**PLANNED UNIT DEVELOPMENT  
& ZONING AMENDMENT STAFF REPORT****Date: December 21, 2017****APPLICANT NAME**

Longleaf Gates Subdivision, Phase Two

Planned Unit Development approval to amend a previously approved Planned Unit Development to allow a private street subdivision, and Rezoning from R-2, Two-Family Residential District, R-3, Multiple-Family Residential District and B-2, Neighborhood District, to R-2, Two-Family Residential District to allow a single-family residential subdivision and eliminate split zoning.

SITE PLAN

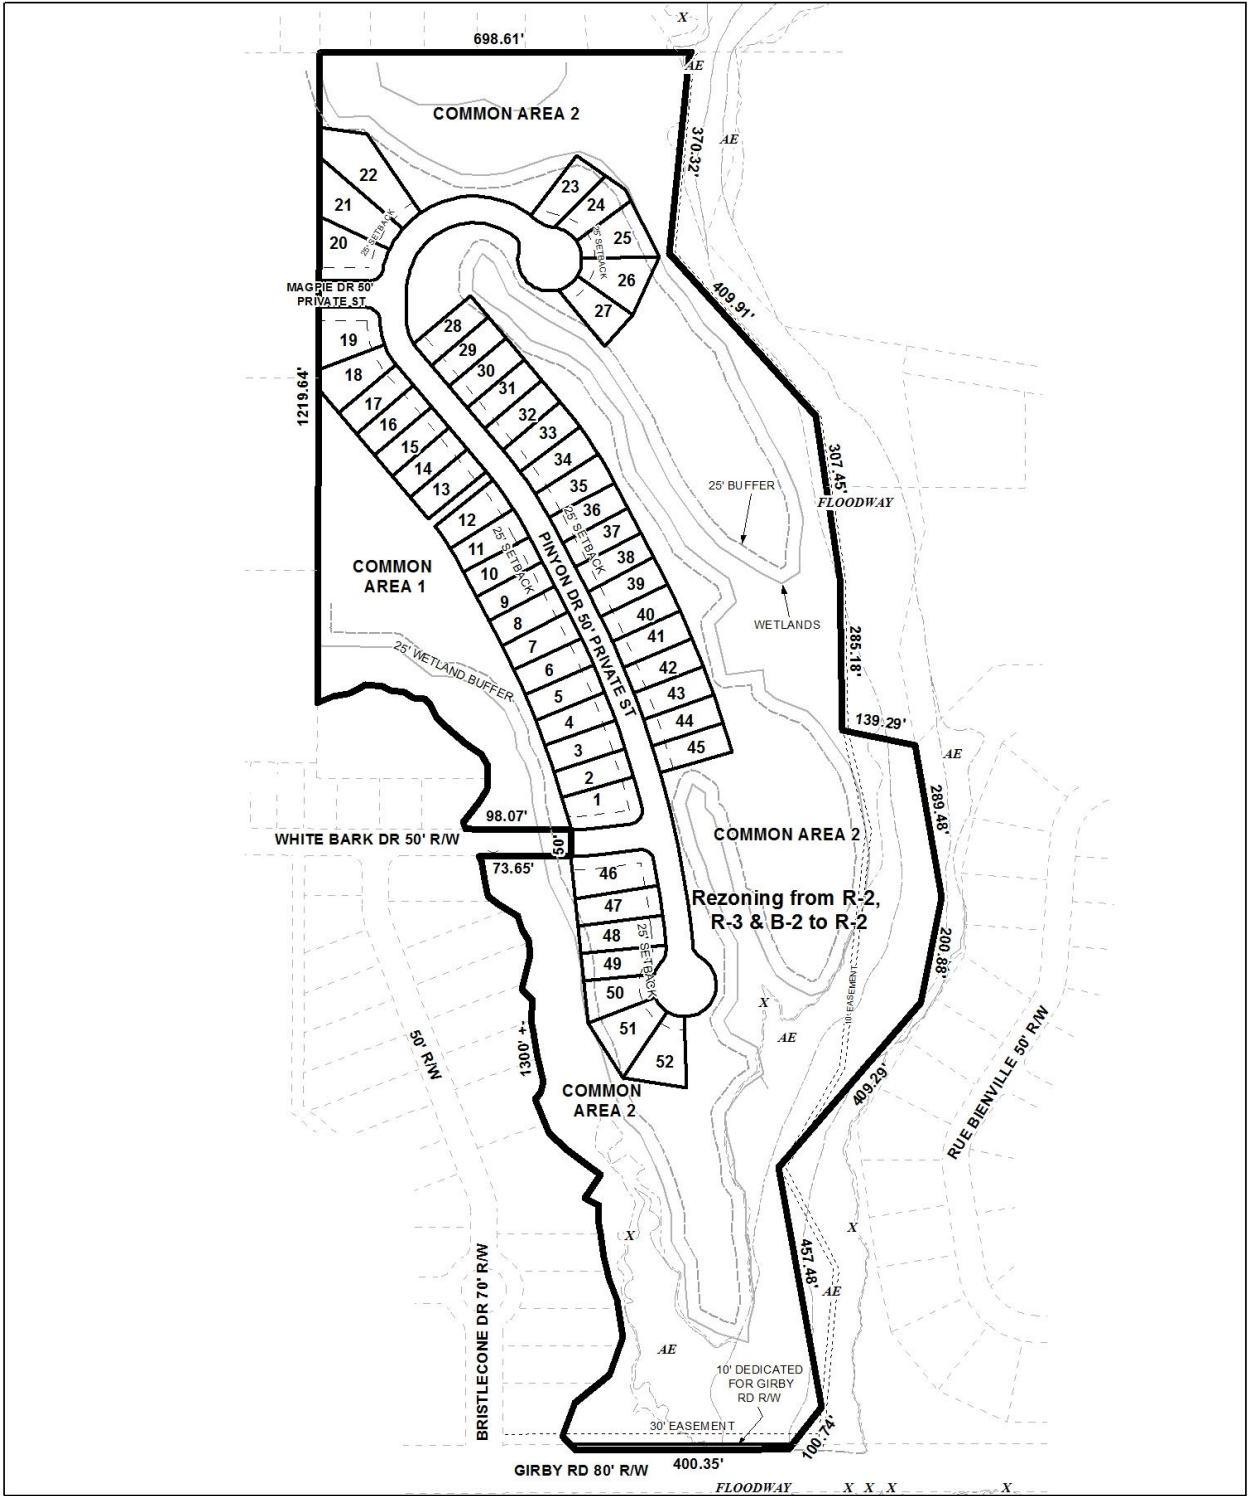
The site plan provided by the applicant is similar to the most recently submitted preliminary subdivision plat, whereon 52 lots and two (2) common areas are proposed, and are to be accessed by the aforementioned extension of White Bark Drive, as well as an additional, proposed private street, Pinyon Drive. A private street stub labeled "Magpie Drive" is also proposed. Each lot would meet the minimum size requirements for lots served by public water and sanitary sewer systems, and no reduced setbacks or increased lot coverages are being requested; however, labeling of the lot sizes in both square feet and acres should be required on a revised PUD site plan, or provision of a table on the PUD site plan providing the same information should suffice.

Regarding the proposed common areas, their sizes should also be provided in both square feet and acres on a revised PUD site plan; or, the applicant may provide a table on the PUD site plan providing this information. Also, a note should be provided on the PUD site plan stating that the maintenance of all common areas is the responsibility of the property owners and not the City of Mobile.

The 25' minimum building setback line is illustrated along the street frontages of all proposed lots, but is not labeled; and no building setback line is illustrated along Girby Road. As such, revision of the PUD site plan to illustrate the 25' minimum building setback line along all street frontages should be required.

Sufficient right-of-way dedication is illustrated along all existing and proposed street frontages and, per Subdivision review, should be retained on the Final Plat, if approved. Such dedications should also be retained on the PUD site plan.

The proposed private Pinyon Drive is provided with cul-de-sacs at both terminuses in compliance with Section VIII.E.1.a. of the Subdivision Regulations. They also appear to comply with Section V.B.14. regarding the required 120' turnaround right-of-way diameter.

It should be noted that Section VIII.E.1.a. does not allow private streets to serve adjacent properties and the proposed street stub labeled "Magpie Drive" would be accessible by property not owned by the applicant. The 2009 approval of the overall subdivision conditioned additional street-stubs to connect adjacent public streets and landlocked properties for emergency access only; therefore, the Magpie Drive street stub should be labeled as "emergency access only" leading to the vacant property to the West. Also, labels indicating the private status of the proposed street and street stub(s) should be retained on the PUD site plan.

If approved, a note should be provided on the PUD site plan stating that maintenance of the private streets is the responsibility of the property owners. An additional note should be placed on the PUD site plan stating that, if the private streets are not constructed and maintained to City standards inasmuch as they could ultimately be dedicated for public use and maintenance, then 100 percent of the cost of the improvements required to do so shall be assessed to the property owners at the time the private streets are dedicated.

In coordination with the proposed Subdivision plat, a note should be placed on the PUD site plan stating each lot and common area is limited to one curb cut, with any changes in their sizes, locations, or designs to be approved by Traffic Engineering and conform to AASHTO standards. An additional note denying direct access to Common Area 2 from Girby Road should also be provided on the PUD site plan, if approved.

Multiple easements are illustrated on the PUD site plan, including a 10' sanitary sewer easement along the East property line and a 30' sewer easement along Girby Road. A note stating a 10' drainage and utility easement is dedicated along the frontage of all proposed lots and along lot lines abutting a right-of-way is also provided. As such, if approved, an additional note should be required on the revised PUD site plan stating no structures shall be constructed in any easement.

**Planned Unit Development:** Based on the preceding, the Planned Unit Development is recommended for Holdover to the January 4, 2018 meeting, with revisions submitted by December 28, 2017, to allow the applicant time to address the concerns regarding adjacent property ownership and access to Whitebark Drive, as well as to address the following:

- 1) revision of the site plan to label the sizes of the proposed lots and common areas in both square feet and acres, or provision of a table on the site plan providing the same information;
- 2) placement of a note on the site plan stating that the maintenance of all common areas is the responsibility of the property owners and not the City of Mobile;
- 3) revision of the site plan to illustrate the 25' minimum building setback line along all street frontages;
- 4) placement of a note on the site plan stating the development of the private streets shall be in compliance with Section VIII of the Subdivision Regulations;
- 5) revision of the site plan to label Magpie Drive with "emergency access only";
- 6) placement of a note on the site plan stating that maintenance of the private streets is the responsibility of the property owners and not the City of Mobile;

- 7) placement of a note on the site plan stating that, if the private streets are not constructed and maintained to City standards inasmuch as they could ultimately be dedicated for public use and maintenance, then 100 percent of the cost of the improvements required to do so shall be assessed to the property owners at the time the private streets are dedicated;

- 8) placement of a note on the site plan stating each lot and common area is limited to one curb cut, with any changes in their sizes, locations, or designs to be approved by Traffic Engineering and conform to AASHTO standards;

- 9) placement of a note on the site plan stating that direct access to Common Area 2 from Girby Road is denied;
- 10) placement of a note on the site plan stating that no structures shall be constructed in any easement;
